Planning Commission Meeting

November 10, 2020 6:00 PM

Justin Honore submitted a request for site plan review to construct a new single--family dwelling with a detached garage at 236 Mt. Zion Road, Parcel Identification Number 14 0094-0009-011-6. The property is zoned R--1, One-Family Detached and is subject to the Neighborhood Conservation Area of the Architectural Design Standards.

Title: Site Plan Review-236 Mt Zion Road Revisions

⑥ Site Section
3/16" = 1'-0"

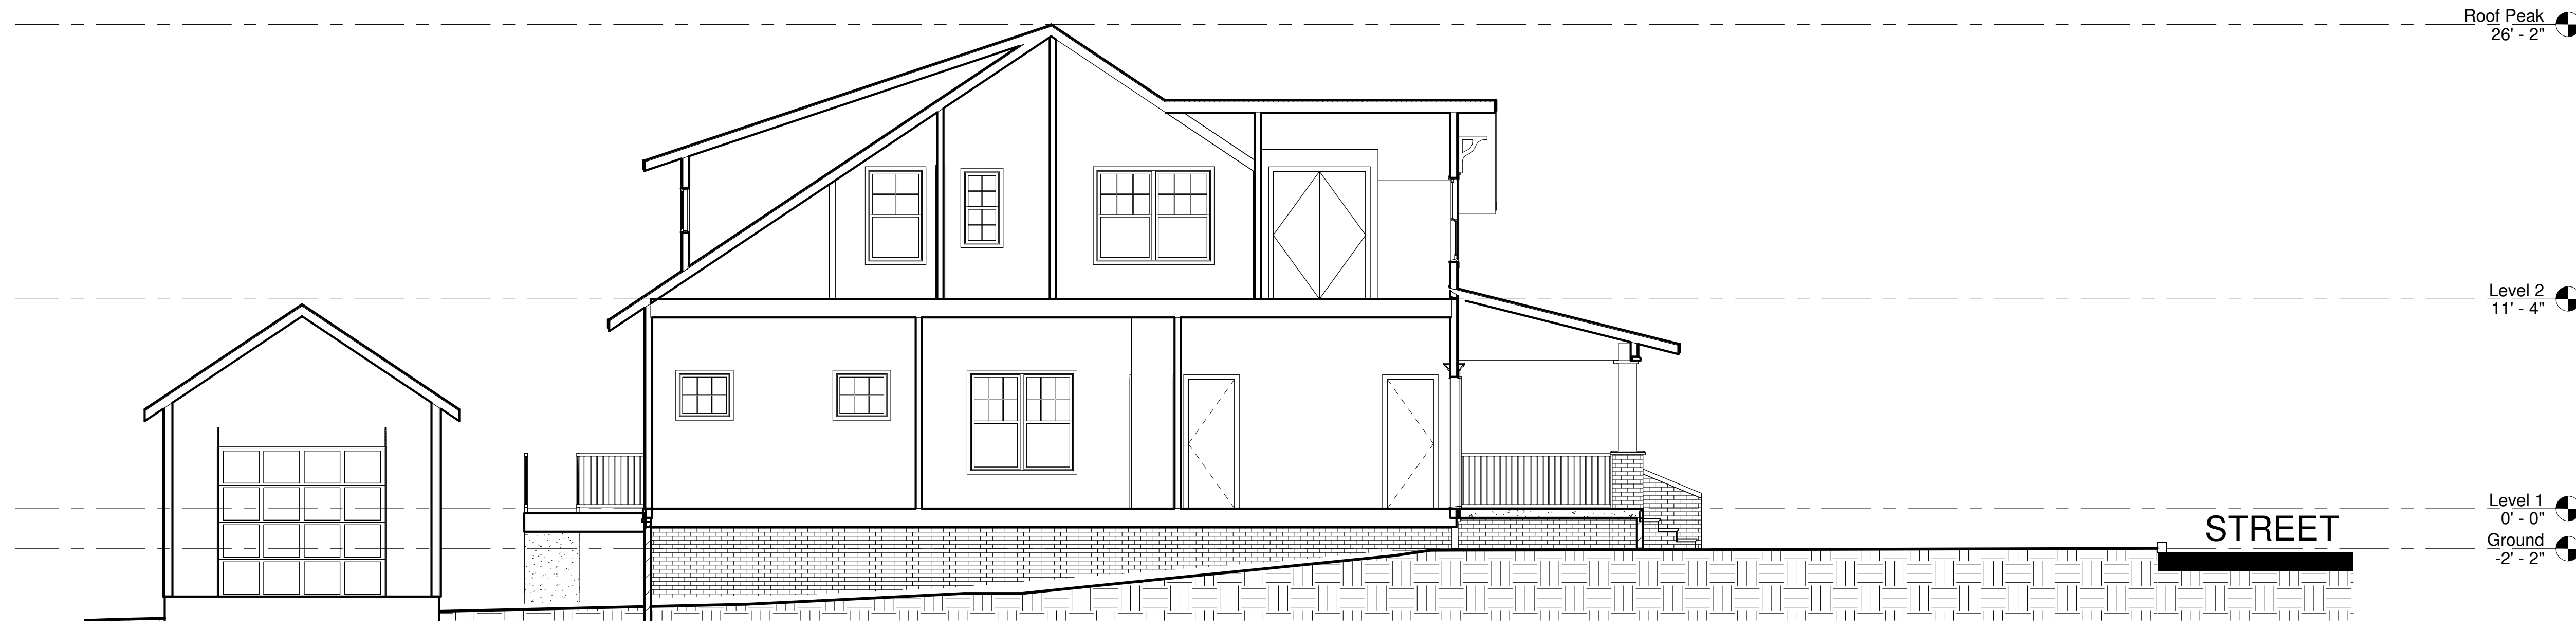
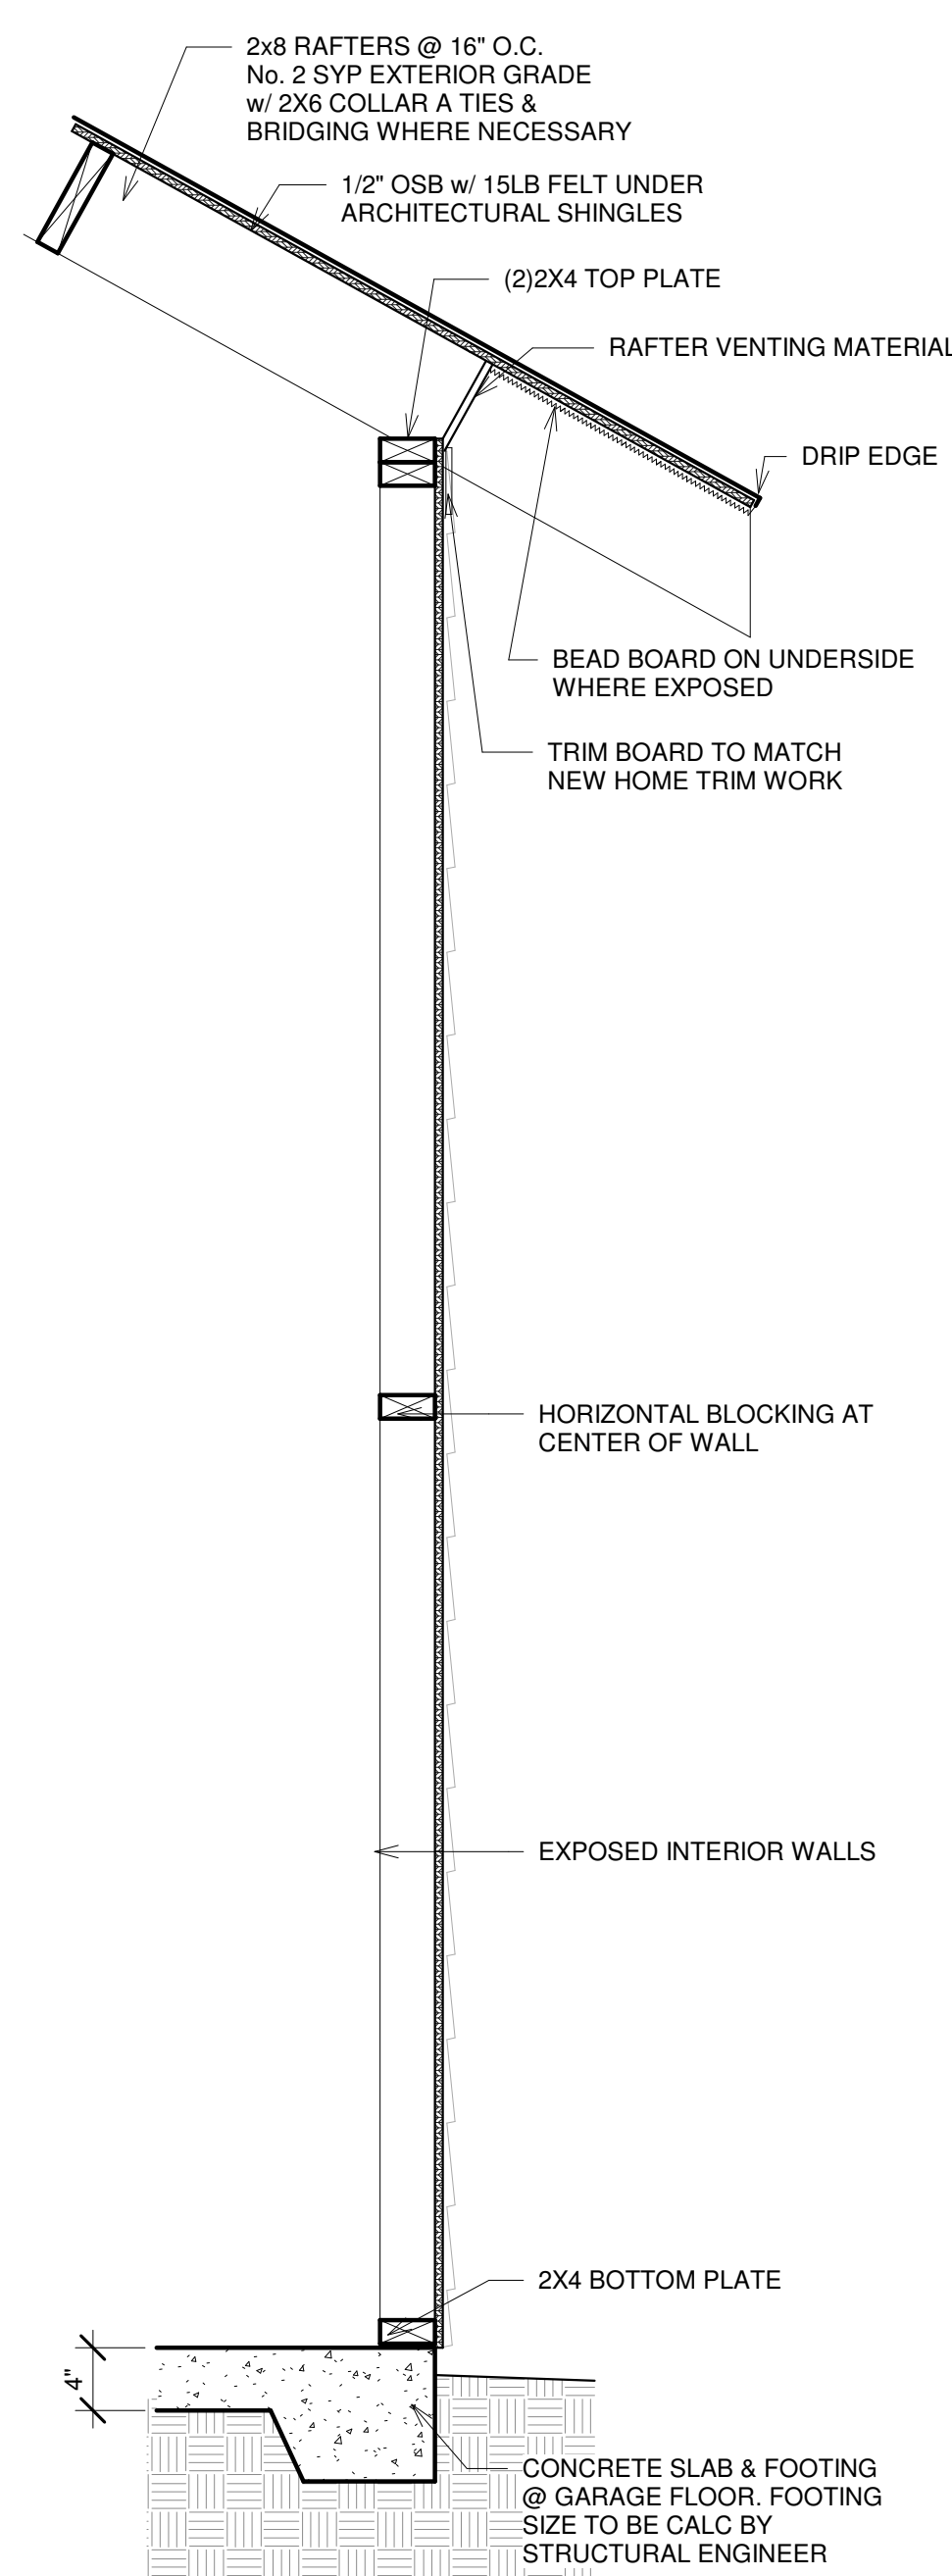
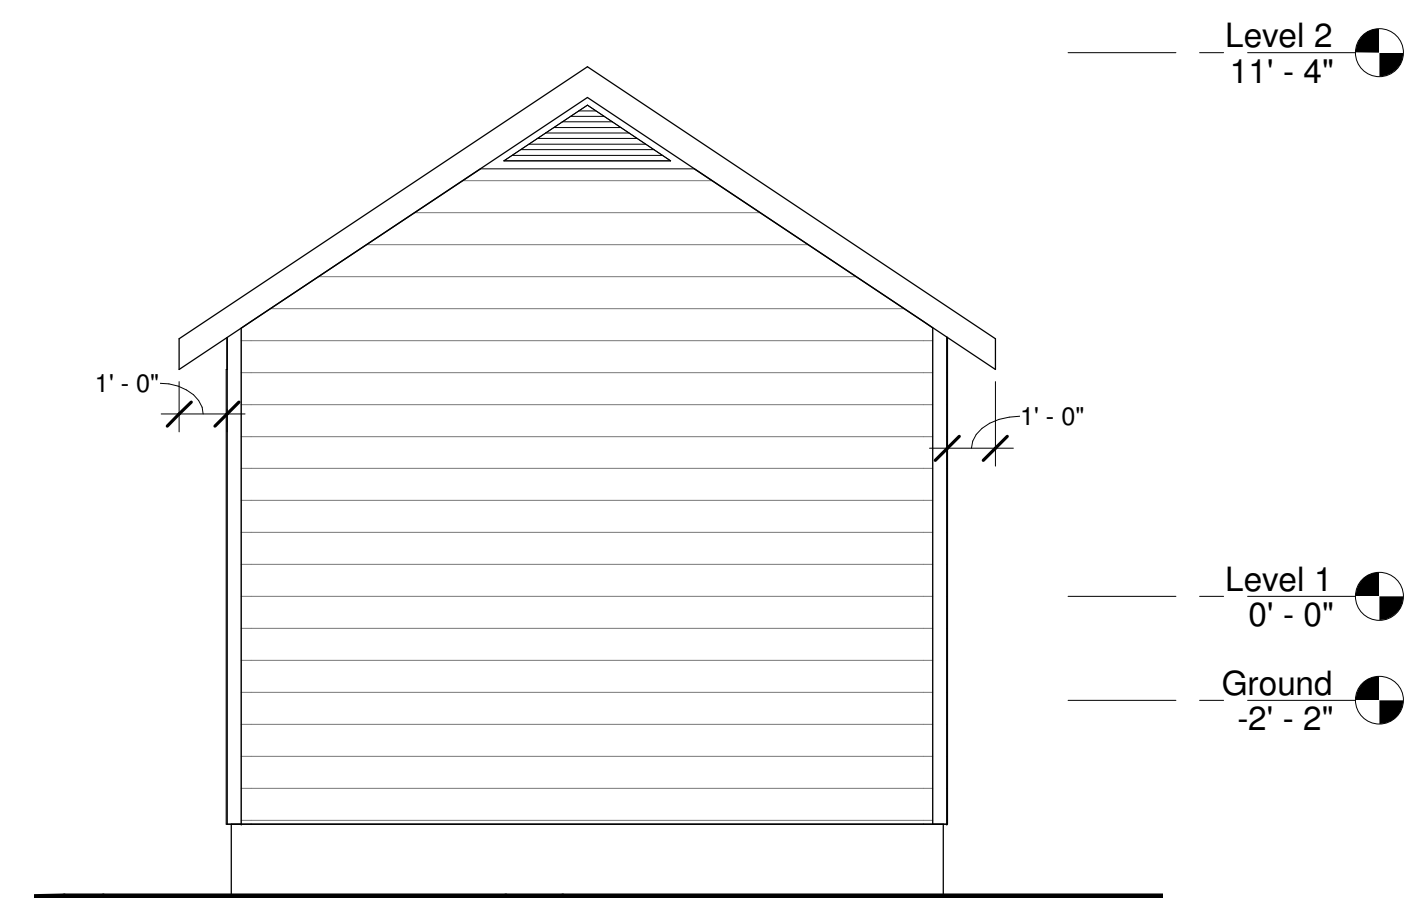
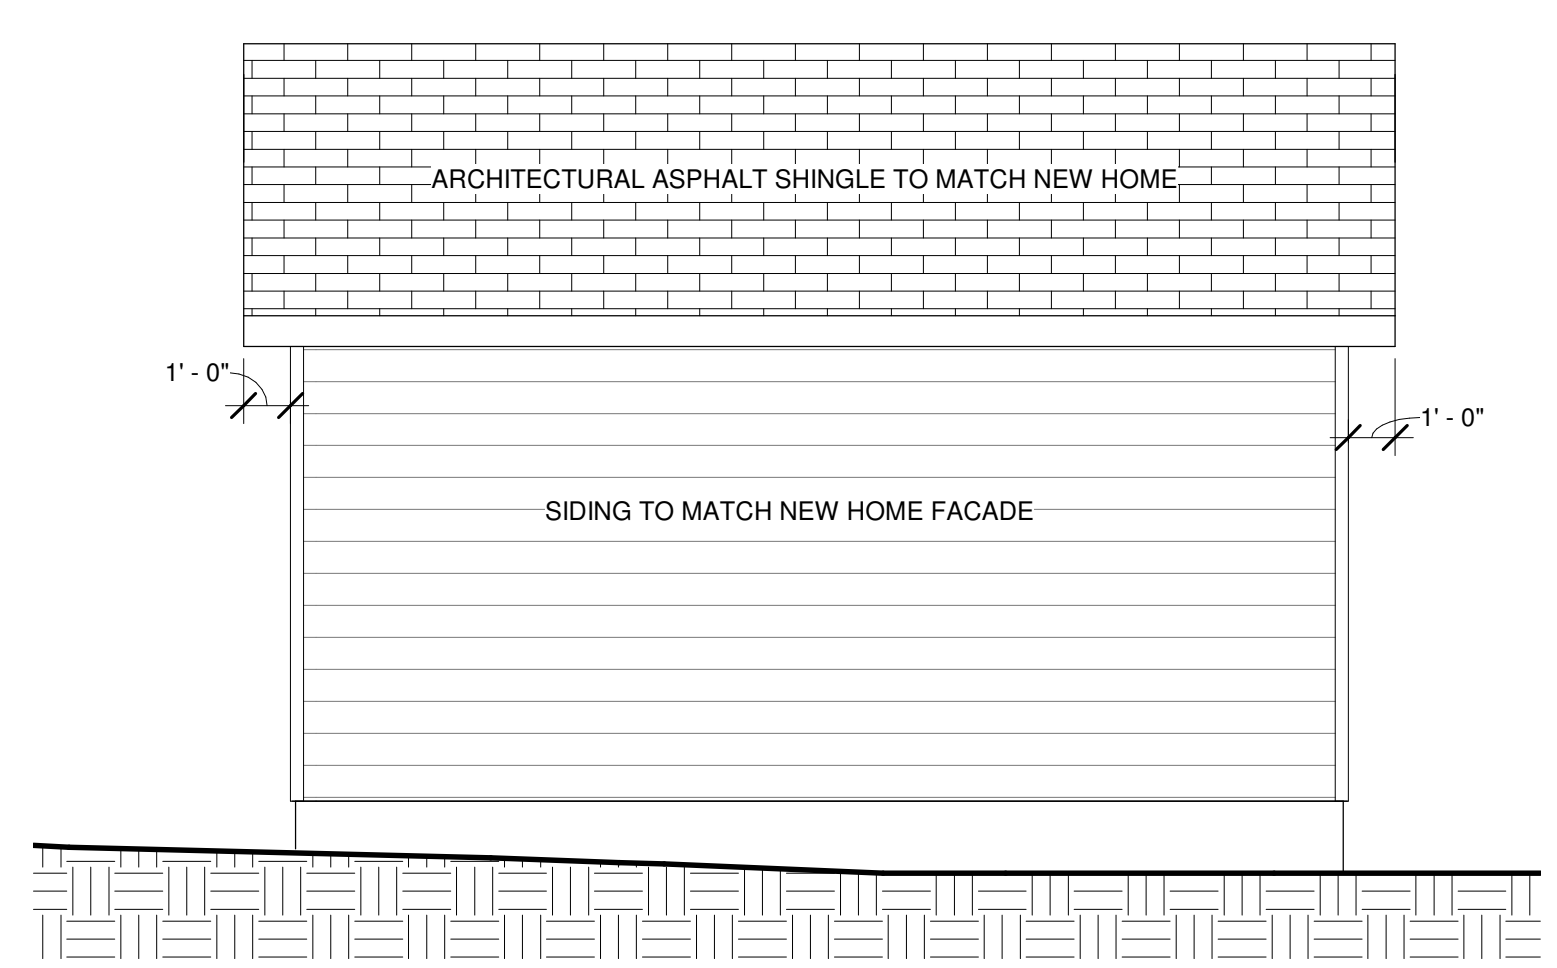
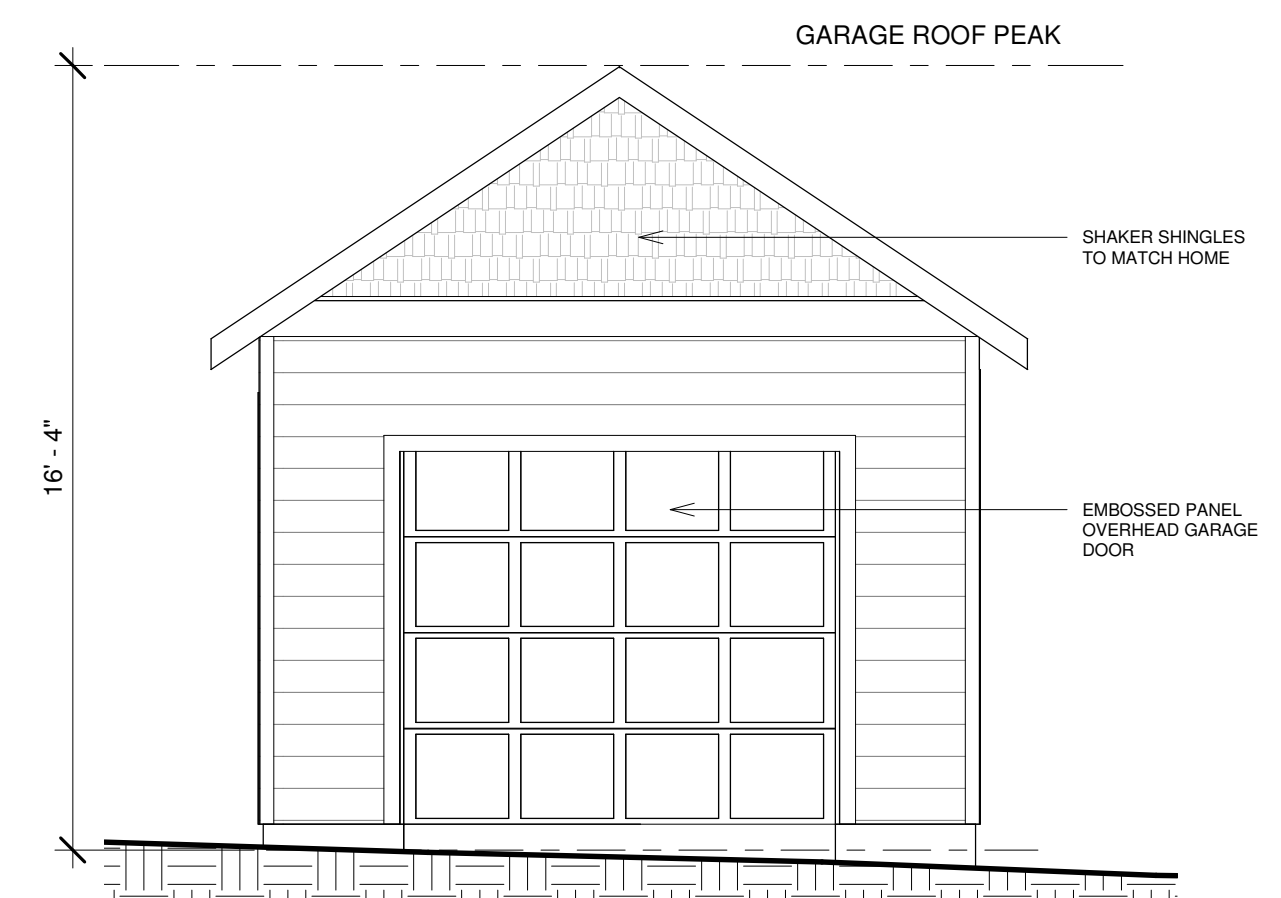
- A dry pit/standpipe design is shown on the site plan.
- (2) Site and building sections. Schematic or illustrative sections shall be drawn to .scale of 1" = 8' or larger, necessary to understand the relationship of internal building elevations to adjacent site elevations.

- The building elevations will be reviewed by the Design Review Committee for compliance with the Architectural Design Standards. No detail for the garage has been provided.

- The building elevations will be reviewed by the Design Review Committee for compliance with the Architectural Design Standards. No detail for the garage has been provided.

- Section Provided on sheet A7 detail 6 -Site Section

- New garage details on sheet A7
